ASHLAND PLANNING COMMISSION

PLANNING ACTION: PA-T2-2024-00053
SUBJECT PROPERTY: 231 Granite Street
PROPERTY OWNERS: Stephanie & Bryan DeBoer
APPLICANTS: Carlos Delgado Architect
DESCRIPTION: A request for a Physical and Environmental (P&E) Constraints permit to construct a new single-family dwelling in steep slopes greater than 25% within the hillside overlay area, including exceptions to the hillside design standards. The proposal includes a Type 2 variance due to the proposed driveway grade exceeding 18%. The applicant also requests a tree removal permit to remove 67 trees, 63 of which are between 6" and 12" Diameter at Breast Height (DBH), 8 of which are dead, and 4 are significant trees which are larger than 12" DBH. **COMPREHENSIVE PLAN DESIGNATION:** Low Density Residential; **ZONING:** RR-.5; **MAP:** 39 1E 08 DA; **TAX LOTS:** 1800

RE: **APPLICANT FINAL WRITTEN ARGUMENT/REBUTTAL**
Planning Action: PA-T2-2024-00053
Applicants: Bryan & Stephanie DeBoer
Subject Property: 231 Granite Street (39-1E-08DA, Tax Lot 1800)

Subject: Rebuttal Regarding Planning Action PA-T2-2024-00053: 231 Granite St.

Screenshot of Map Submitted by Pacific Crest Surveying on 03/13/2025 (Eisenberg) and 03/18/2025 (McLaughlin):

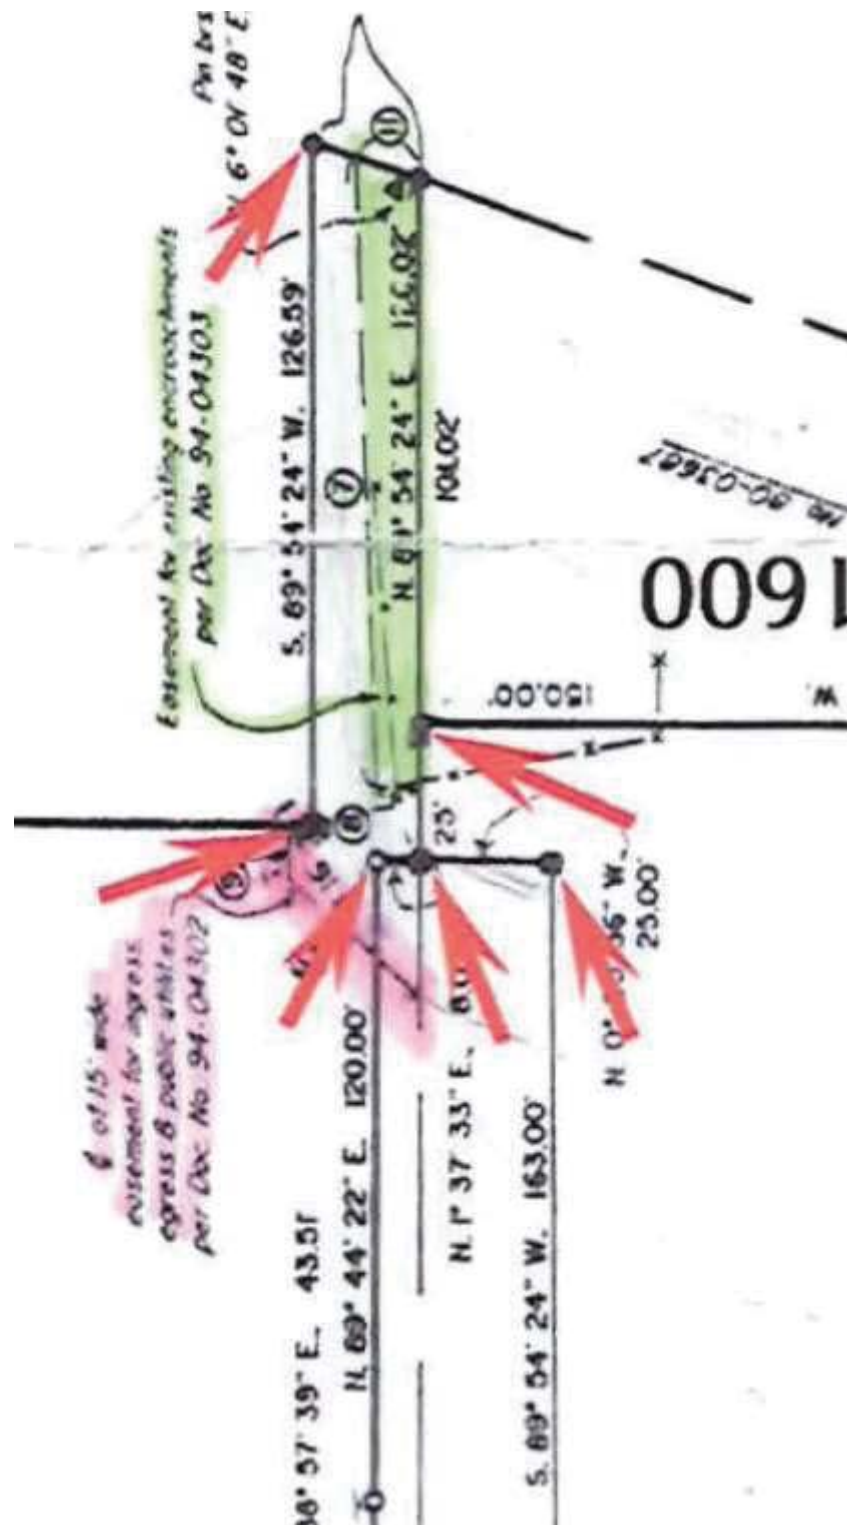
On March 11, 2025, we surveyed and established the boundary line common to the Deboer parcel (Tax Lot 391E8DA 1800) and the McLaughlin parcel (Tax Lot 391E8DA 700) and the trees at the proposed driveway access point.

Our survey determined that the trunks of the 10" and 12" Pacific Madrone, and the 16" Oregon White Oak, tree numbers 68 and 71 respectively, as on Sheet L0.3 (Tree Removal Plan) straddle said common boundary line.

Additionally, a 32" Madrone not shown on the Tree Removal Plan, which is in the vicinity of the proposed driveway access point, straddles said common boundary line.

Applicants' Response: Applicants acknowledge the updated survey information confirming that these three trees lie on or very near the shared property line. However, none of these shared trees creates an insurmountable problem for the

project. In fact, Applicant's development plans have now been adjusted to address the neighbor's concerns and to preserve the two property-line trees (#68 the oak, and #71 the small madrone). As noted above, the driveway design was slightly shifted and construction methods will be employed (under the project arborist's guidance) to protect those two trees so they can remain in place. The only large tree on the border – the ~34" madrone at the northeast flag lot corner – falls within the driveway easement area and is slated for removal, but that tree is entirely within the recorded access easement and its removal is permitted as part of Applicants' legal rights under the terms of the Easement Agreement (i.e. the Applicants have the legal right to remove it as necessary to allow use their access for its intended purpose). In any event, any tree that technically lies on a property line will only be removed in compliance with legal requirements – meaning if neighbor consent is required, Applicants will obtain it, or if consent is not granted, the plans will be adjusted to retain the tree. Applicants have every intention of being good neighbors and will work with the McLaughlins regarding any co-owned trees. Notably, by revising the plan during the post-hearing period, the only shared tree now planned for removal is the large madrone lying directly within the easement, and that removal is necessary for access and allowed by the terms of Applicant's recorded easement. This is a manageable issue and not grounds for denial. In fact, Ms. Gunter's March 25 memo confirms that the minimum number of significant trees are being removed to accommodate development, and that all such removals are necessary for the driveway, the residence footprint, or the wildfire safety buffer – none are being taken out gratuitously. Even with these removals, there will be no significant reduction in overall tree canopy or diversity in the vicinity. The shared trees in question do not derail the project: Applicants will either secure the neighbors' consent or simply design around the shared trees if need be (as they have already done for two of them). The Tree Removal Permit criteria are met, as detailed above – the removal is the minimum necessary for the project and will not have significant adverse impact on the area. (For additional details on tree protection measures, please refer to the March 25 Gunter Rebuttal and the arborist's reports in the record.) Finally, to reiterate: the large madrone located within the driveway easement may be removed under the terms of that easement, so its straddling the property line does not prevent the driveway improvements from moving forward.

Screenshot from Record Showing Madrone Obstructing Applicant's Recorded Access Easement:

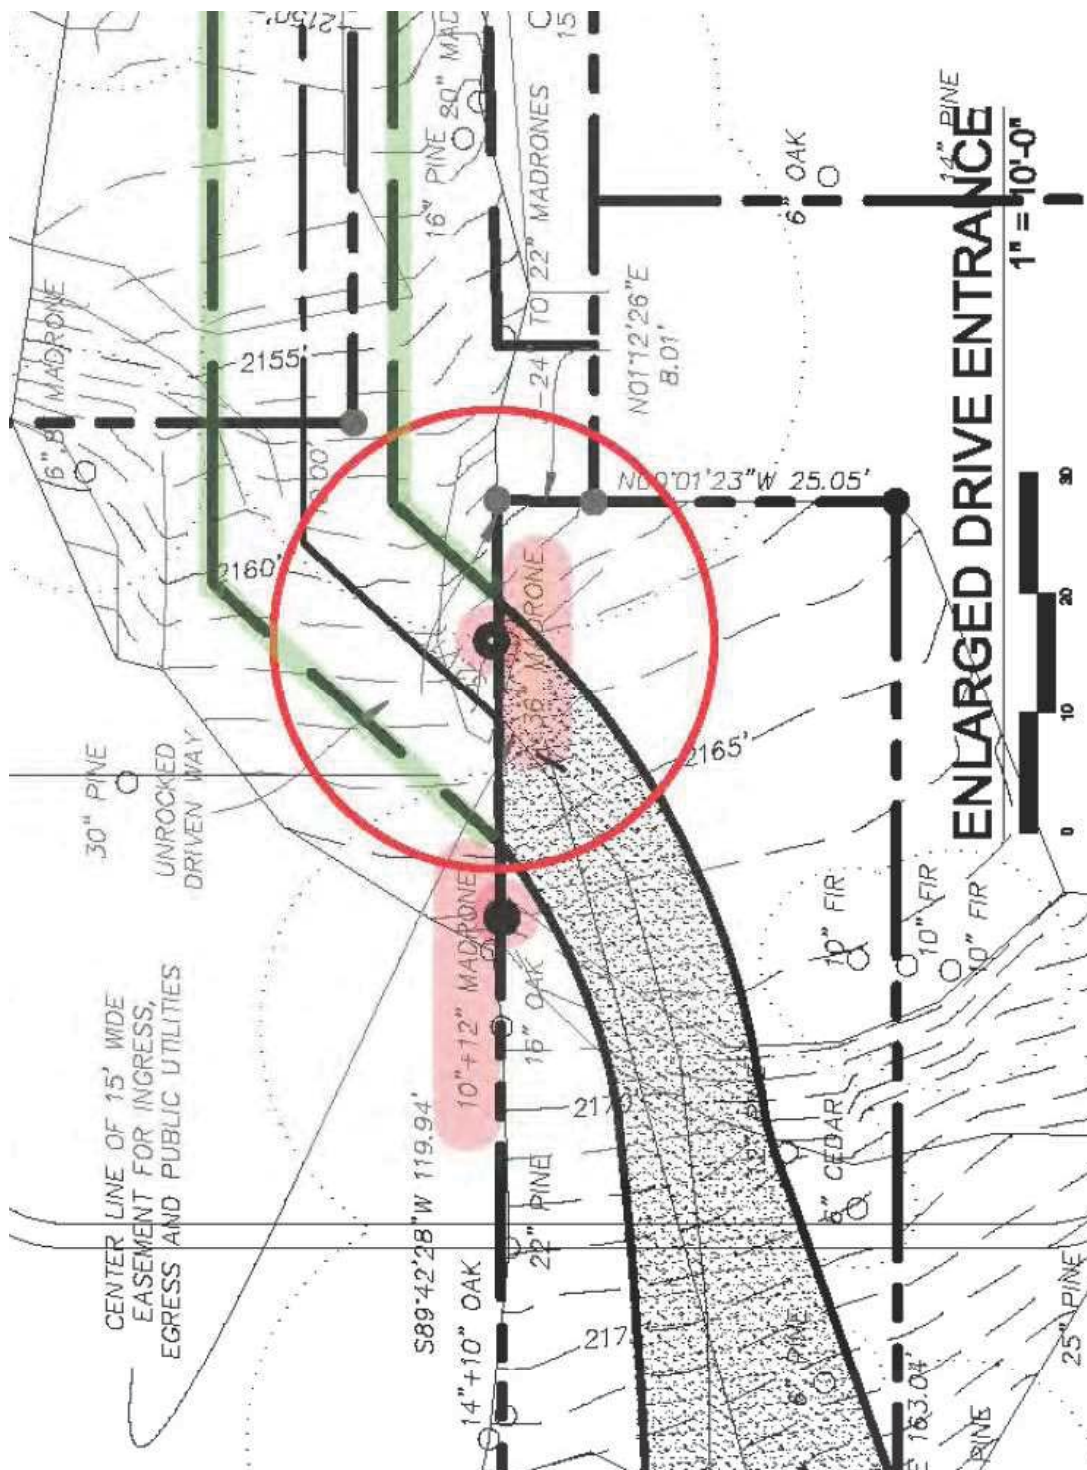
There are 5. The fifth tree is a 30" dbh madrone near the northeast corner of the flag portion of the lot, and is not plotted on any of the tree survey or tree removal plan maps. This 30"dbh madrone, and two trees that are slated for removal on the Tree Removal map L0.3 (pg 28 of the pdf), (a 16" oak and a two stem 10" and 12"), all appear to straddle the property line between

SHEET :
A2.2

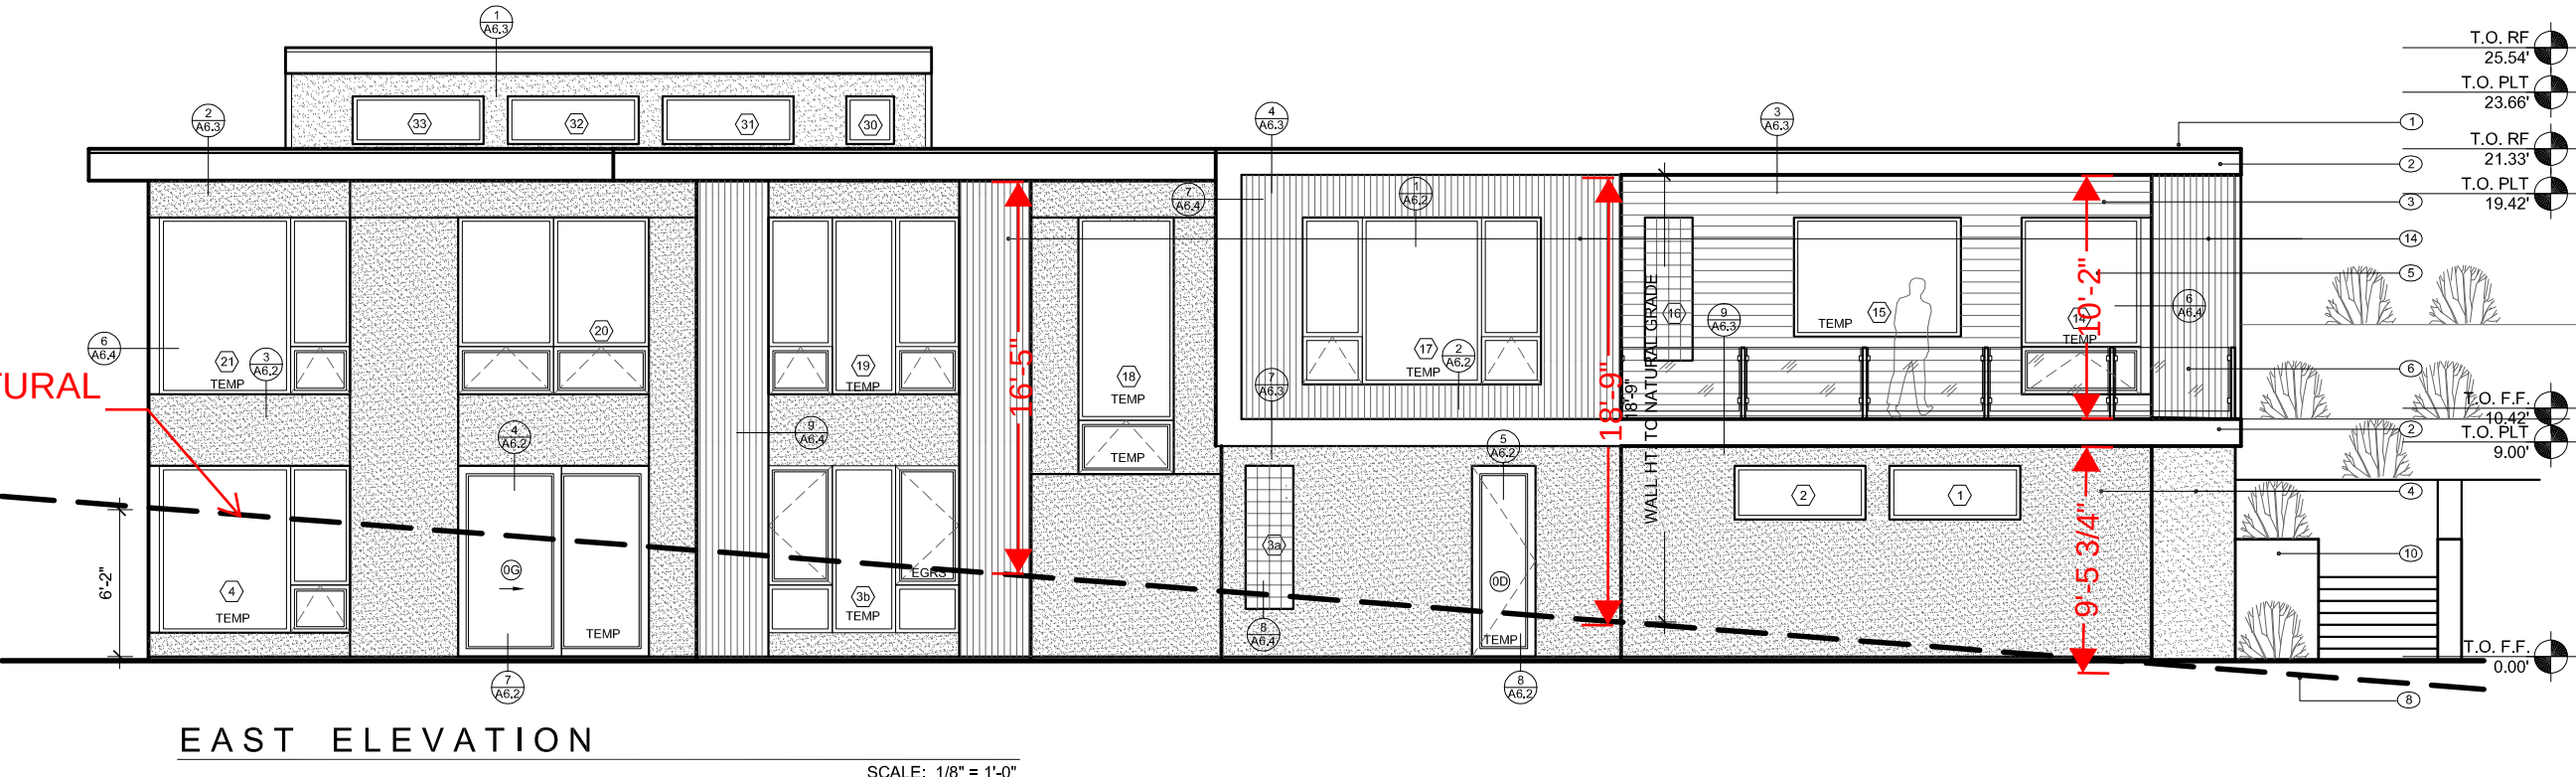
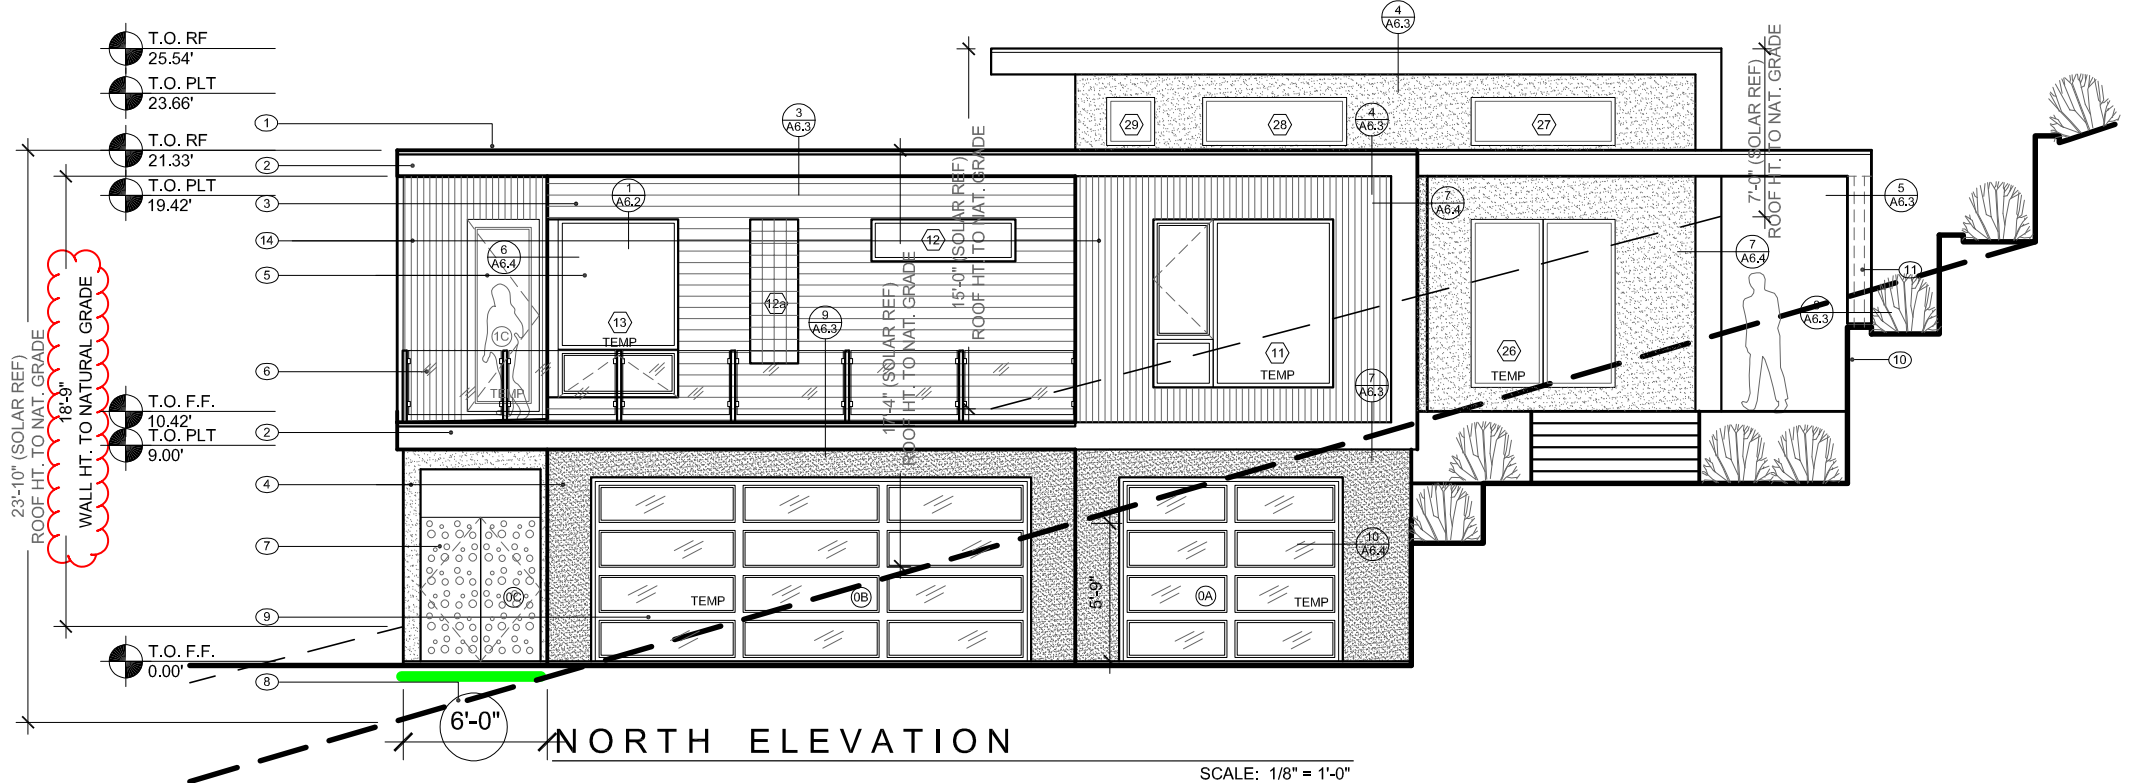
This exception has been eliminated from the east and south sides of the proposed structure through footprint and façade alterations that increase the offsets to six feet. This also reduces the floor area of the home by 44 square feet. See attached sheet A1.0., A1.1., A2.2., and A2.1.
